**Title:**

Review Sketch Plan for Riverstone South; Case of Capstone Homes

# Changemarks Report

**CONCEPT PLAN  
 RIVERDALE ALIGNMENT  
 DETAIL**

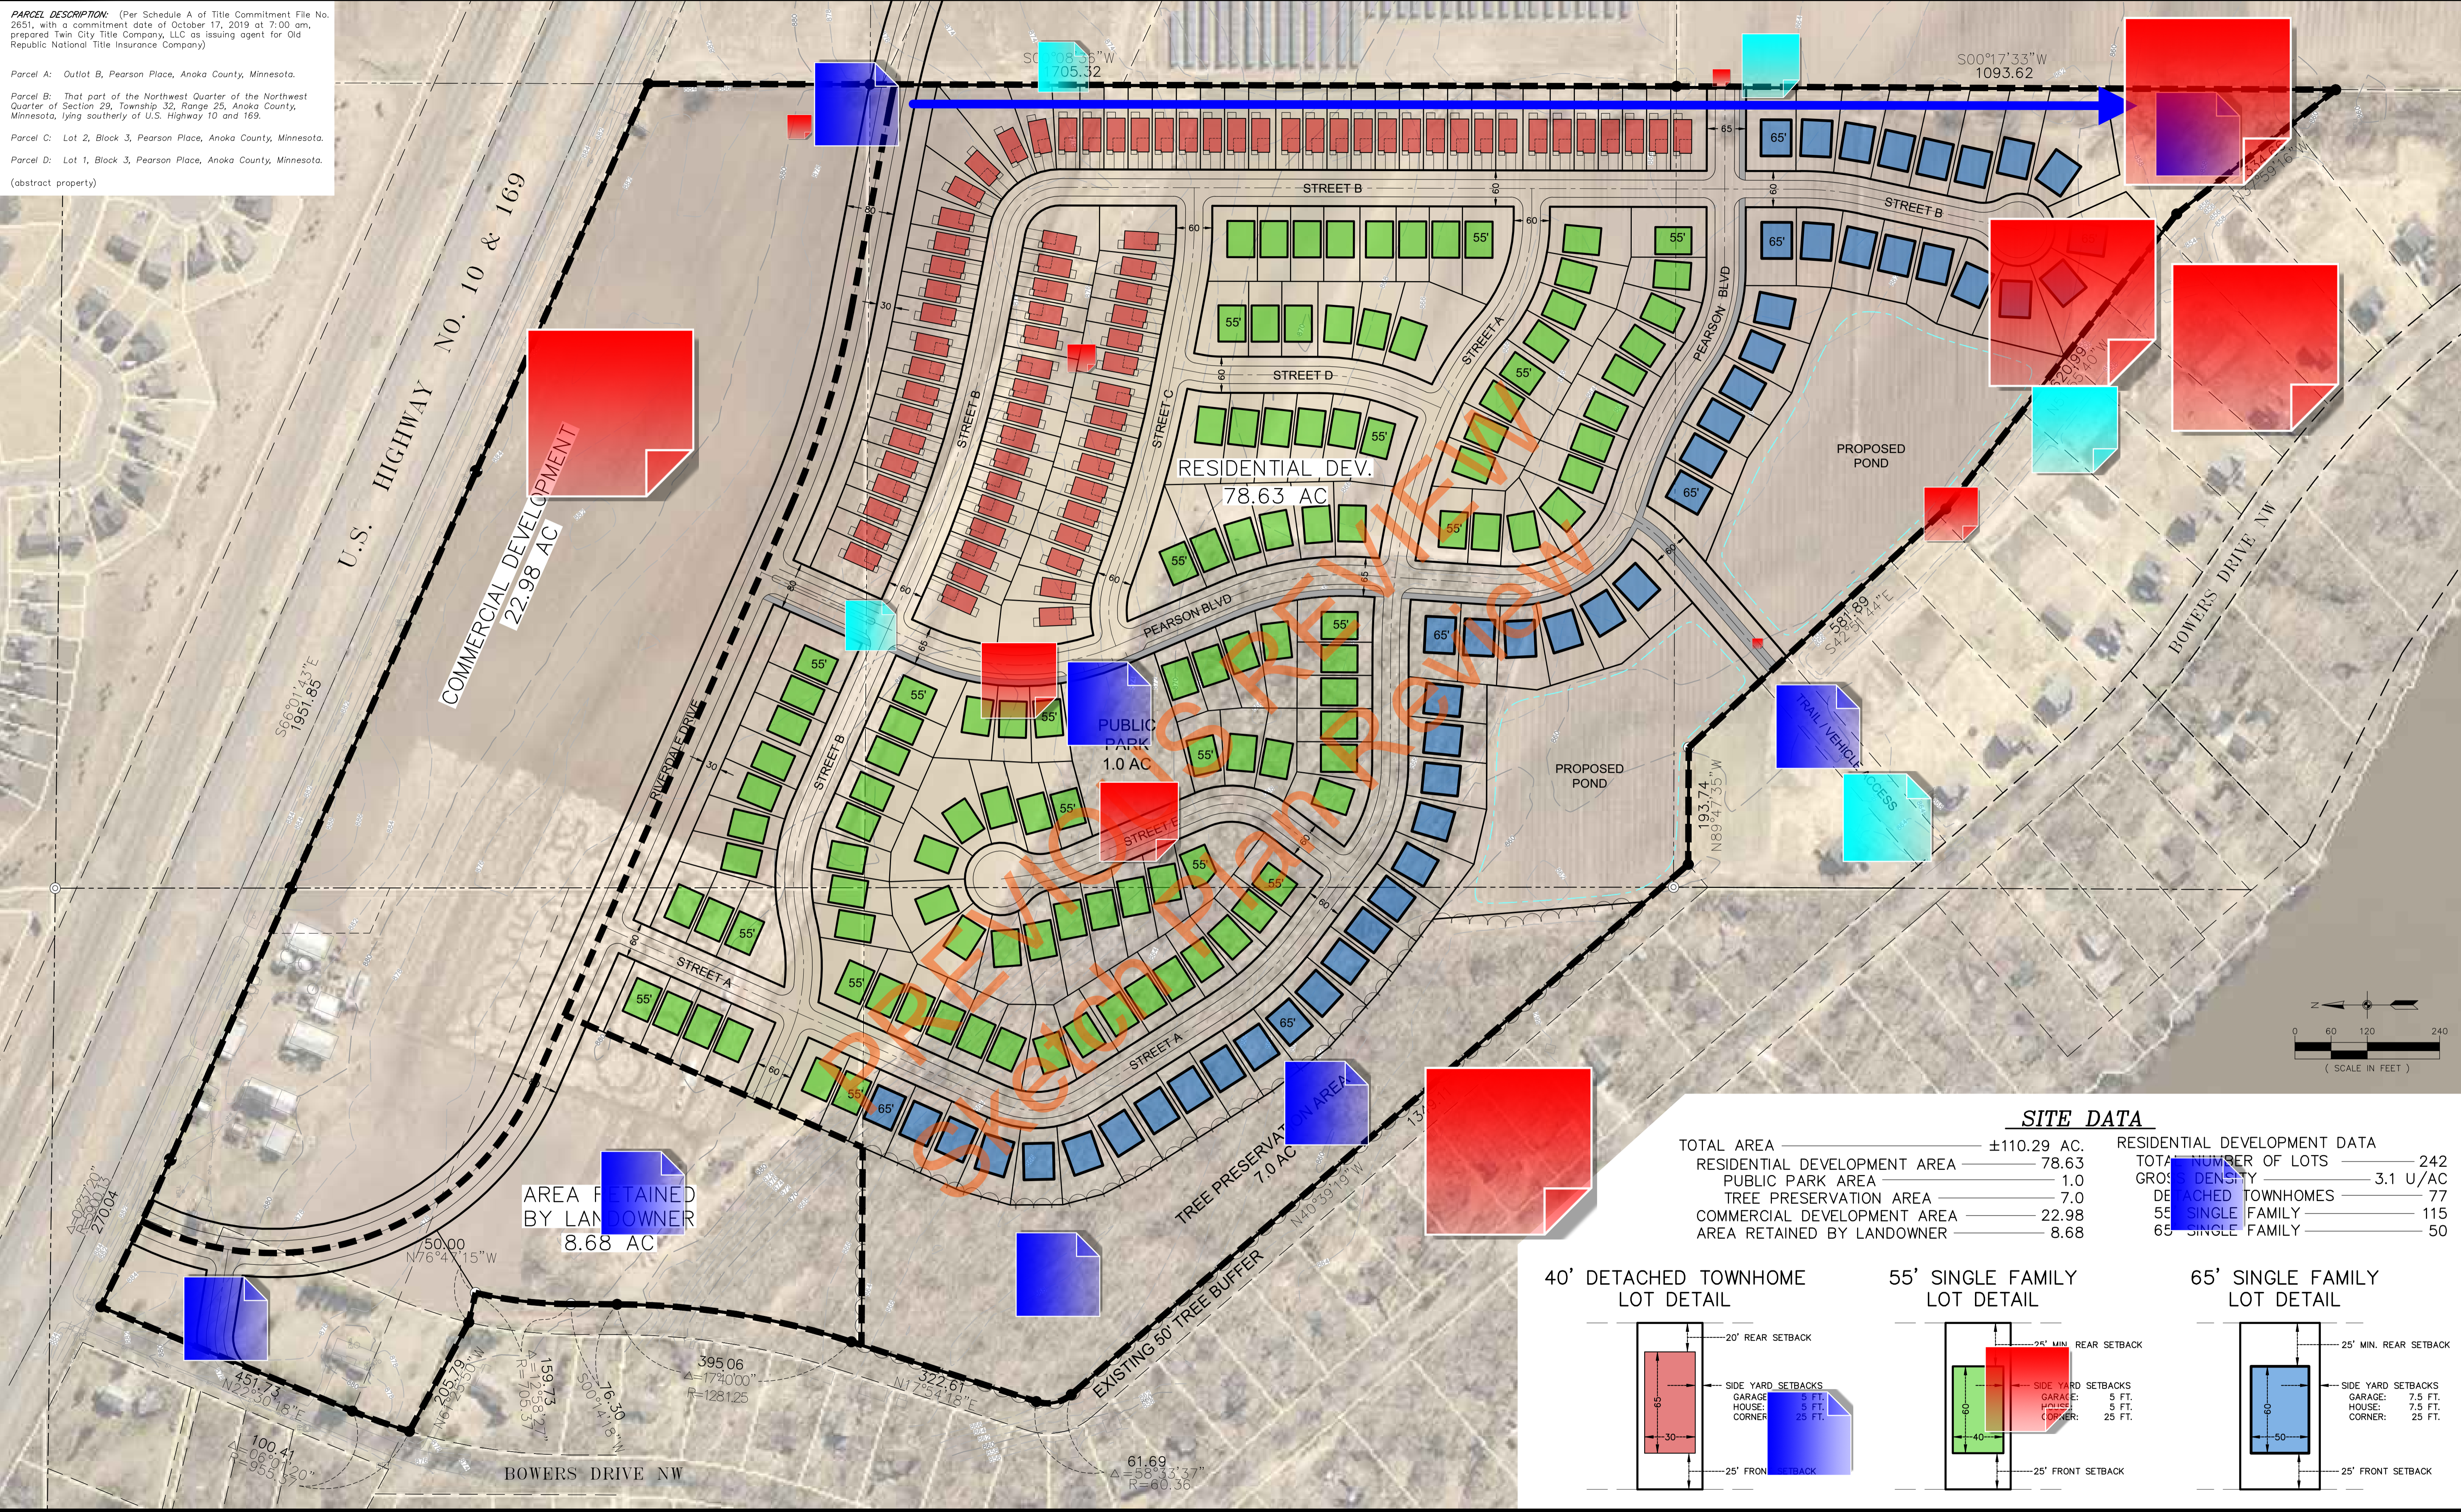
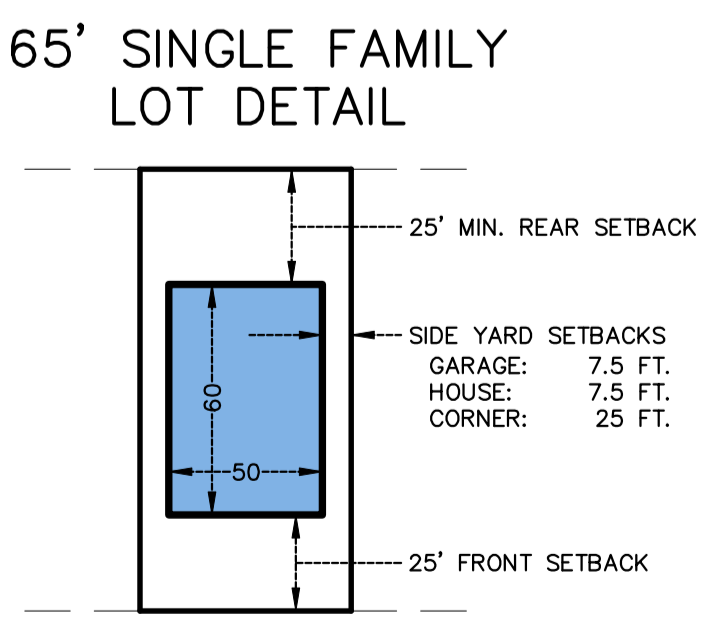
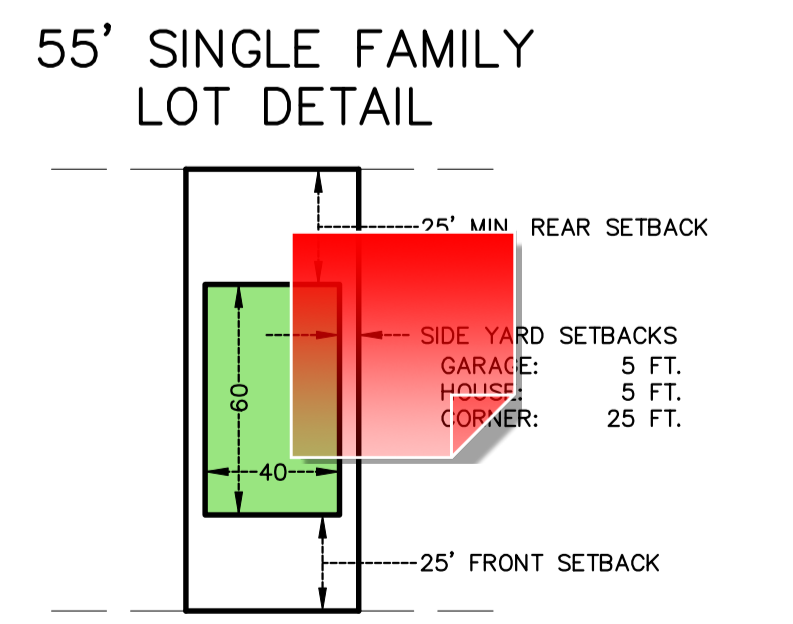
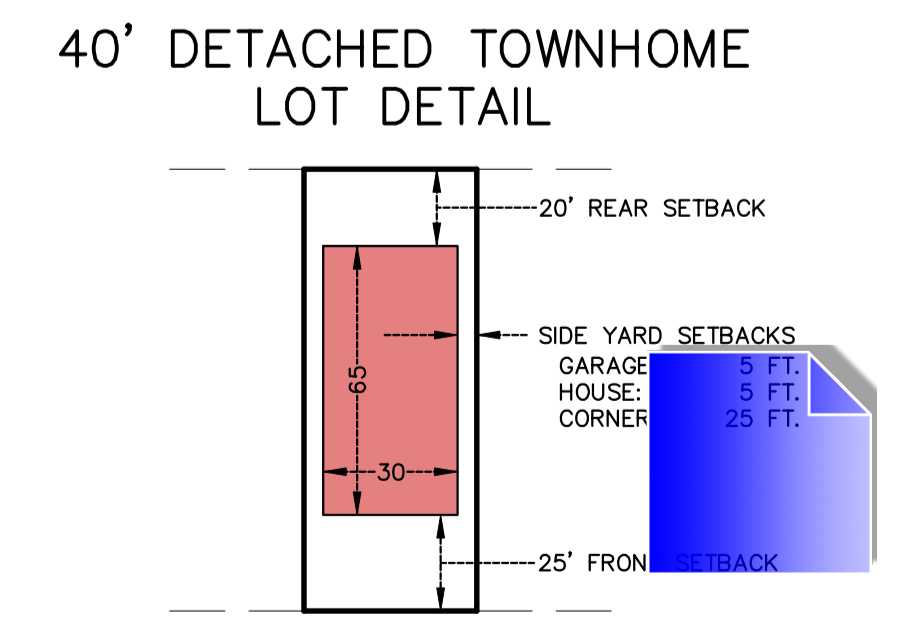
Grouping	Cycle	Ref #	Complete?	Status	Department	Snapshot	File	Markup Name	Changemark Subject	Changemark Details	Markup Date	Updated By	Applicant Response
Main Workflow	1	28	False	Unresolved	Civil Engineer IV		Riverstone South Sketch Plan.pdf	LL	Stormwater Route	The project to the south showed stormwater overflow from their pond onto this site. The overflow route for this site must be called out on the preliminary plat.	07/29/2020 3:23 PM	Len Linton	
		29	False	Unresolved	Civil Engineer IV		Riverstone South Sketch Plan.pdf	LL	Cul-de-sac	This must be a full cul-de-sac, losing the lots on either side of the stub until the next phase develops.  The proximity of this stub to the south line of the solar farm limits future development until the solar farm is closed and the land redeveloped.	07/29/2020 3:23 PM	Len Linton	
		30	False	Unresolved	Civil Engineer IV		Riverstone South Sketch Plan.pdf	LL	Trunk Sanitary Sewer	Trunk Sanitary Sewer will require dedication of adequate drainage and utility easements. Layout may need to be changed to provide the necessary easements.  A forcemain from the lift station will also be required which will require additional easement width.	07/29/2020 3:23 PM	Len Linton

Grouping	Cycle	Ref #	Complete?	Status	Department	Snapshot	File	Markup Name	Changemark Subject	Changemark Details	Markup Date	Updated By	Applicant Response
Main Workflow	1	31	False	Unresolved	Civil Engineer IV		Riverstone South Sketch Plan.pdf	LL	Street Widths	Street widths must be 32 feet or the lot widths must be increased. The 29 foot lots require restriction of parking to one side of the street. The combination of narrow lot width and driveway width limit the number of available parking spaces even more with parking on one side of the street.	07/29/2020 3:23 PM	Len Linton	
		32	False	Unresolved	Civil Engineer IV		Riverstone South Sketch Plan.pdf	LL	Bowers Drive Access	Coordinate Bowers Drive access with plans from previous development on Bowers Drive.  Provide street access through this area.	07/29/2020 3:23 PM	Len Linton	
		27	False	Unresolved	Civil Engineer IV		Pearson South Riverdale Realignment.pdf	LL	Sight Distance at intersection	Consider increasing building setback from Riverdale to provide better site distance from left.	07/29/2020 2:46 PM	Len Linton

22	False	Unresolved	Civil Engineer II		Riverstone South Sketch Plan.pdf	JJF	Existing Ponding Combination	Please consider working with the adjacent property owners to possibly combine the ponding for this site with the existing pond put in with the Pearson Place development. This pond is adjacent to the proposed pond as shown.	07/29/2020 2:52 PM	Joe Feriancek	
		23	False	Unresolved	Civil Engineer II		Riverstone South Sketch Plan.pdf	JJF	Bowers Drive Connection	My understanding is this connection was going to be a road connection rather than a trail. A road connection would make the most sense in my opinion.	07/29/2020 2:52 PM	Joe Feriancek

Grouping	Cycle	Ref #	Complete?	Status	Department	Snapshot	File	Markup Name	Changemark Subject	Changemark Details	Markup Date	Updated By	Applicant Response
Main Workflow	1	24	False	Unresolved	Civil Engineer II		Riverstone South Sketch Plan.pdf	JJF	Pearson Blvd/Stub location	The stub location does not appear to leave much buildable area on the north side of the road if the next parcel develops before the Solar Farm site develops.	07/29/2020 2:52 PM	Joe Feriancek	
		25	False	Unresolved	Civil Engineer II		Riverstone South Sketch Plan.pdf	JJF	Trunk Sewer Line	To give more comment to Tim's comment, it is not desirable for the City to have trunk utilities, or any sanitary or water utilities in green space due to access/maintenance concerns.	07/29/2020 2:52 PM	Joe Feriancek	
		26	False	Unresolved	Civil Engineer II		Riverstone South Sketch Plan.pdf	JJF	home types	Do you have a plan with proposed house types, or not that far along yet? Are the townhomes planned to be slab on grade, spacing wise they appear close together to have a walkout type design.	07/29/2020 2:52 PM	Joe Feriancek

Grouping	Cycle	Ref #	Complete?	Status	Department	Snapshot	File	Markup Name	Changemark Subject	Changemark Details	Markup Date	Updated By	Applicant Response
Main Workflow	1	12	False	Unresolved	City Planner		Riverstone South Sketch Plan.pdf	Chloe	Bowers Drive Lots	Measure width of Bowers Drive lots (average or one or two is fine)	07/22/2020 2:48 PM	Chloe McGuire Brigl	
		13	False	Unresolved	City Planner		Riverstone South Sketch Plan.pdf	Chloe	Lot Depth	Indicate lot depth of these parcels for context	07/22/2020 2:48 PM	Chloe McGuire Brigl	
		14	False	Unresolved	City Planner		Riverstone South Sketch Plan.pdf	Chloe	Lot Depth	Indicate lot depth of this parcel	07/22/2020 2:48 PM	Chloe McGuire Brigl	
		15	False	Unresolved	City Planner		Riverstone South Sketch Plan.pdf	Chloe	Tree Preservation	Flag these trees as goal of preservation based on utility plan	07/22/2020 2:48 PM	Chloe McGuire Brigl	
		16	False	Unresolved	City Planner		Riverstone South Sketch Plan.pdf	Chloe	Backyard size	Measure size of backyard so we know how close house pads will be to existing property lines	07/22/2020 2:48 PM	Chloe McGuire Brigl

17	False	Unresolved	City Planner		Riverstone South Sketch Plan.pdf	Chloe	Density	Please provide approximate net density across site and per house type	07/22/2020 2:48 PM	Chloe McGuire Brigl	
		11	False	Unresolved	City Planner		Pearson South Riverdale Realignment.pdf	Chloe	Ponding?	Will this leftover piece be used for ponding? If so we should get under DU easement or outlot so it's not read as a buildable parcel	07/22/2020 2:44 PM	Chloe McGuire Brigl	
		1	False	Unresolved	Community Development Director		Riverstone South Sketch Plan.pdf	Tim Gladhill	Label Future Use	Label this as location of future Sanitary Sewer Lift Station	07/21/2020 6:47 PM	Tim Gladhill

Grouping	Cycle	Ref #	Complete?	Status	Department	Snapshot	File	Markup Name	Changemark Subject	Changemark Details	Markup Date	Updated By	Applicant Response
Main Workflow	1	2	False	Unresolved	Community Development Director		Riverstone South Sketch Plan.pdf	Tim Gladhill	Trunk Sanitary Sewer Line	Is there space for the Trunk Sanitary Line in these back yards? How do we access if there is a need for repair?	07/21/2020 6:47 PM	Tim Gladhill	
		3	False	Unresolved	Community Development Director		Riverstone South Sketch Plan.pdf	Tim Gladhill	Revised Connection to Bowers Drive	Update plan set to match new drawing from Pearson/Dobbs.	07/21/2020 6:47 PM	Tim Gladhill	
		4	False	Unresolved	Community Development Director		Riverstone South Sketch Plan.pdf	Tim Gladhill	Connect to Bowers Drive	Must show connection to Bowers Drive.	07/21/2020 6:47 PM	Tim Gladhill	
		5	False	Unresolved	Community Development Director		Riverstone South Sketch Plan.pdf	Tim Gladhill	Contingent Support	The City's support for acquiring this area is contingent upon securing a third-party funding source.	07/21/2020 6:47 PM	Tim Gladhill

6	False	Unresolved	Community Development Director		Riverstone South Sketch Plan.pdf	Tim Gladhill	Ghost Plat	Please provide a separate exhibit that shows a ghost plat for this area.	07/21/2020 6:47 PM	Tim Gladhill	
		7	False	Unresolved	Community Development Director		Riverstone South Sketch Plan.pdf	Tim Gladhill	Linnear Connection - Park to Tree Preservation	Please provide a natural corridor between these two areas.	07/21/2020 6:47 PM	Tim Gladhill	
		8	False	Unresolved	Community Development Director		Riverstone South Sketch Plan.pdf	Tim Gladhill	80 Foot Wide Lots	Previous discussion centered around 80 foot wide lots along the back of the Bowers Drive Neighborhood. Perhaps the City is open in exchange for additional open space preservation.	07/21/2020 6:47 PM	Tim Gladhill	
		9	False	Unresolved	Community Development Director		Riverstone South Sketch Plan.pdf	Tim Gladhill	Zoning Amendment Required	These lot sizes will require a Zoning Amendment and likely a Comprehensive Plan Amendment.	07/21/2020 6:47 PM	Tim Gladhill

Grouping	Cycle	Ref #	Complete?	Status	Department	Snapshot	File	Markup Name	Changemark Subject	Changemark Details	Markup Date	Updated By	Applicant Response
Main Workflow	1	10	False	Unresolved	Community Development Director		Riverstone South Sketch Plan.pdf	Tim Gladhill	Net Density Calculations	Please provide Net Density for the following:  Overall (take out tree preservation area) Area of 65 foot wide lots (R-1 Residential District) Area of 55 foot wide lots and 40 foot wide lots (R-2 Residential District)	07/21/2020 6:47 PM	Tim Gladhill	
		18	False	Unresolved	Engineering Tech		Riverstone South Sketch Plan.pdf	Logan Czech	Parking Spaces	Assuming ~2.5 residents/home this development will house ~600 people. Five parking spaces is not enough for the only park.	07/20/2020 2:42 PM	Logan Czech	
		19	False	Unresolved	Engineering Tech		Riverstone South Sketch Plan.pdf	Logan Czech	Park Size	Since it is the only shared space, one acre is fairly small considering the size of this development. Is there going to be a playground?	07/20/2020 2:42 PM	Logan Czech
